Independent Review of the Bowdens
Silver Pty Limited Surface Water
Assessment – Updated
(Shireen Baguley, March 2022)

Independent Review of the
Bowdens Silver Pty Limited
Surface Water Assessment – Updated
(WRM Water + Environment Pty Ltd
February 2022)

Figure 1 Average monthly rainfall data presented in Bowdens surface water assessment

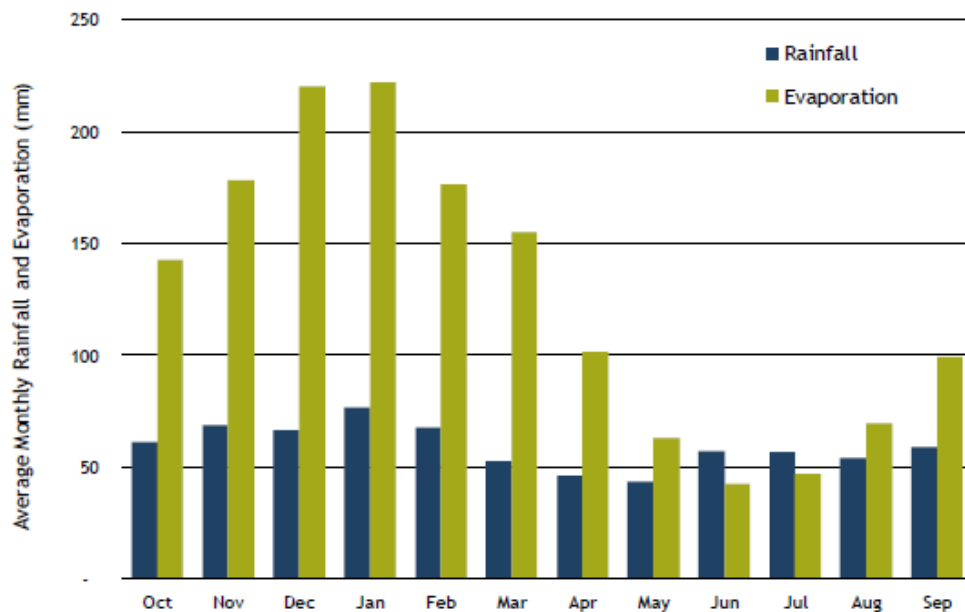
The Bowdens surface water assessment data appears to show a monthly average that exceeds 75mm over summer. This is incorrect, as evidenced by the rainfall data from Mudgee (26km west of the mine site), Rylstone (22km south of the mine site) and Lue.

Many of the other months are also too high when compared to Mudgee, Rylstone and Lue rainfall statistics from BOM. These figures need to be presented as numbers so they can be clearly understood.

Figure 5 Annual monthly rainfall data presented in Bowdens surface water assessment

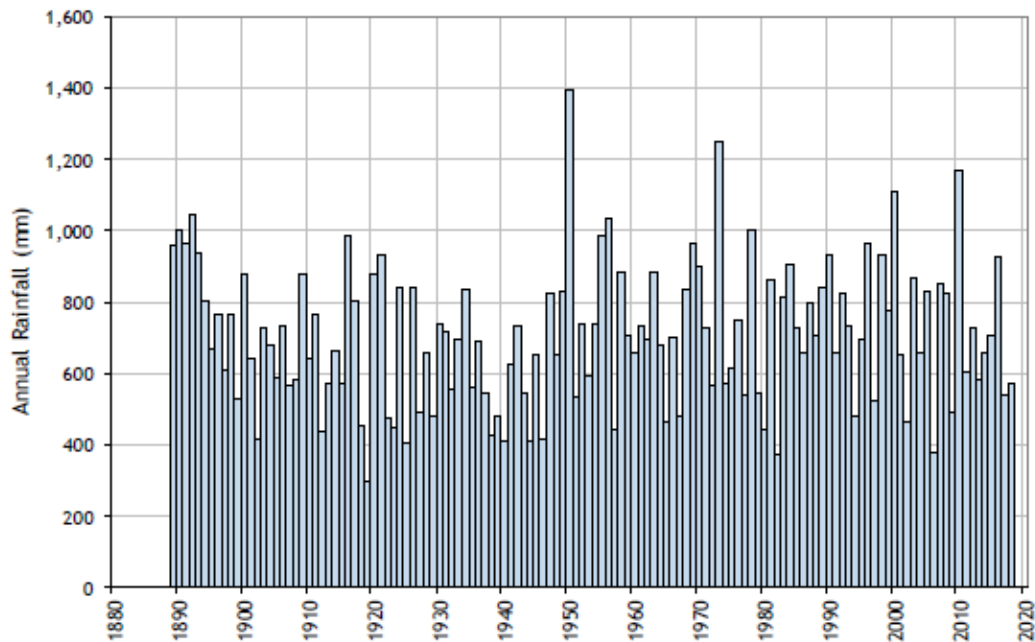
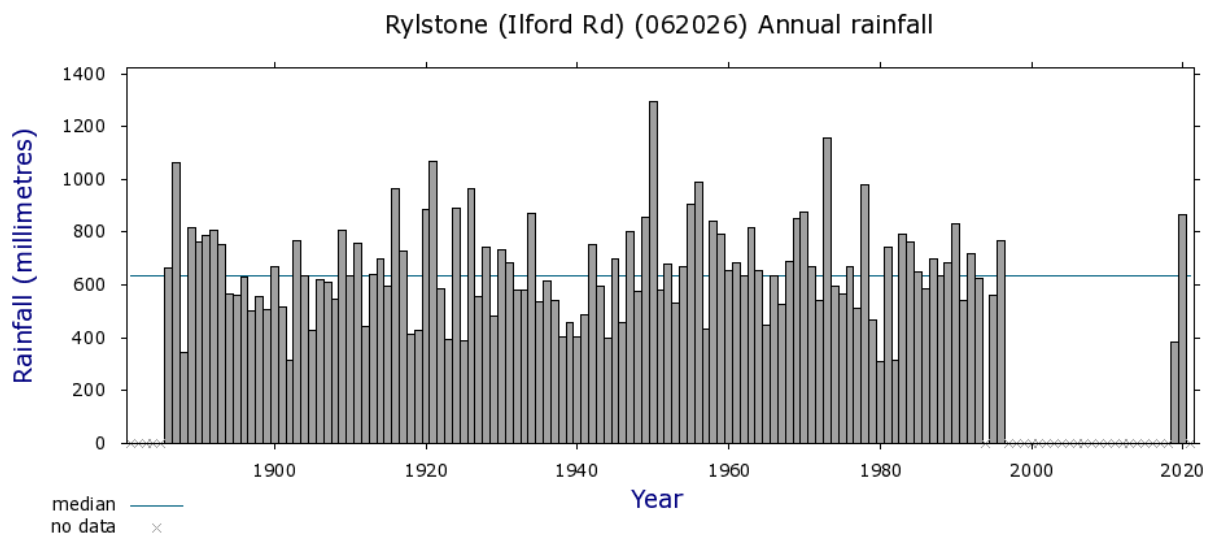
The number of very low rainfall years is clearly not reflected in the Bowdens surface water assessment annual rainfall data, which has only three years of less than 400mm. This in part seems to be a deliberate attempt to distort the data, as it has excluded 1888 and 2019, both of which are very dry years. Given that the community that will be affected by this mine have recently lived through the crippling drought which culminated in the 2019/2020 Black Summer fires, this is viewed very poorly.

WRM reported the average annual rainfall as 673 mm/a. The BOM reports the average annual rainfall for Mudgee as 671 mm/a and 654 mm/a for Rylstone. From Figure 8, it can be seen that the average annual rainfall for Lue is much less, at 614 mm/a. Given this, the estimate of 673 mm/a used by WRM for the surface water assessment is considered unrealistically high. Rather, it would be reasonable to use an estimate of 662 mm/a, being the average of the recorded rainfall for Mudgee and Rylstone. However, it should also be noted that the area in which the mine site lies is generally regarded as being within a rain shadow, with the Great Divide lying to the east and another mountain range to the west. Thus, an average annual rainfall of no more than 654 mm/a may be a more realistic estimate.

Figure 10 Regional Biophysical Strategic Agricultural Land (BSAL)

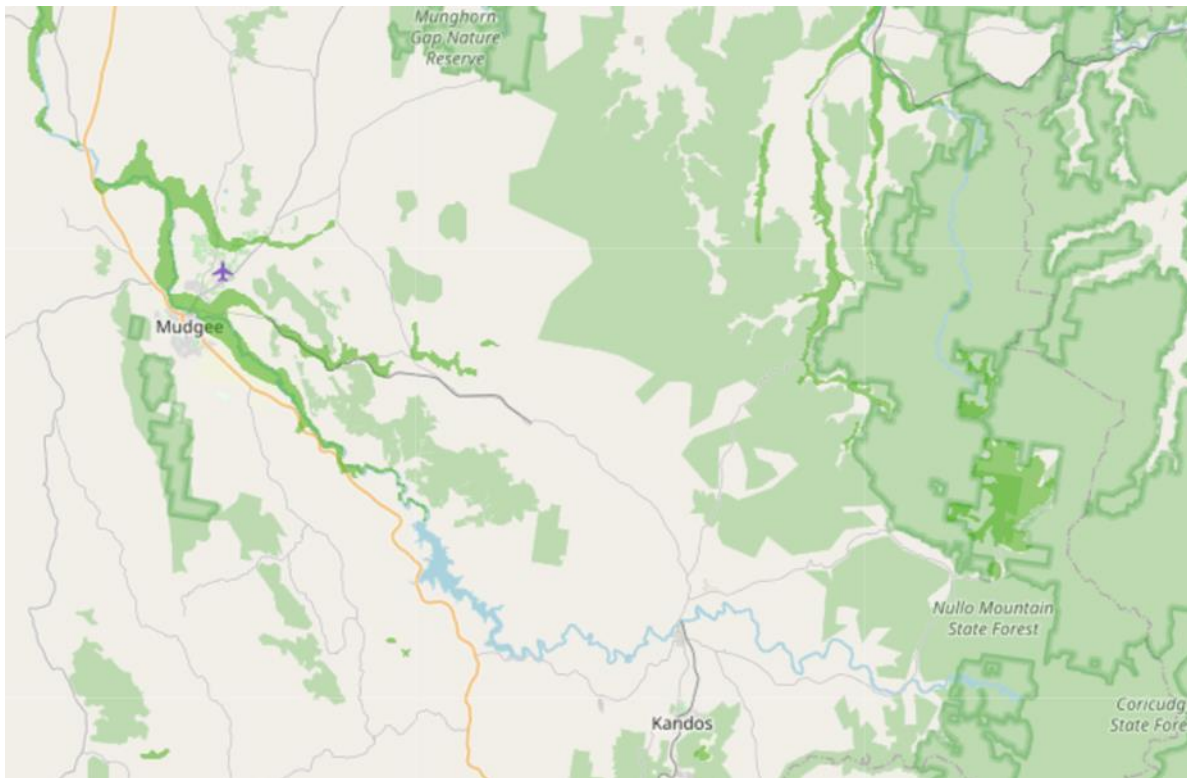
Downstream of the proposed mine site, there is BSAL present (Figure 10). The surface water assessment has not considered the impacts of using water from within Bowdens' holdings on this land.

As has been demonstrated in the analysis in this paper, the catchment in which the mine site is proposed has a high variability in rainfall and frequently experiences dry years. The water that supports the BSAL land moves through the upstream catchment and then is available to support agriculture in the mapped areas. Any mining within the supporting catchments threatens the water resource in the BSAL areas. The proposed mine will interrupt both groundwater and surface water flows, and as such, the BSAL area is at risk of losing the critical water which underpins its inherent value.
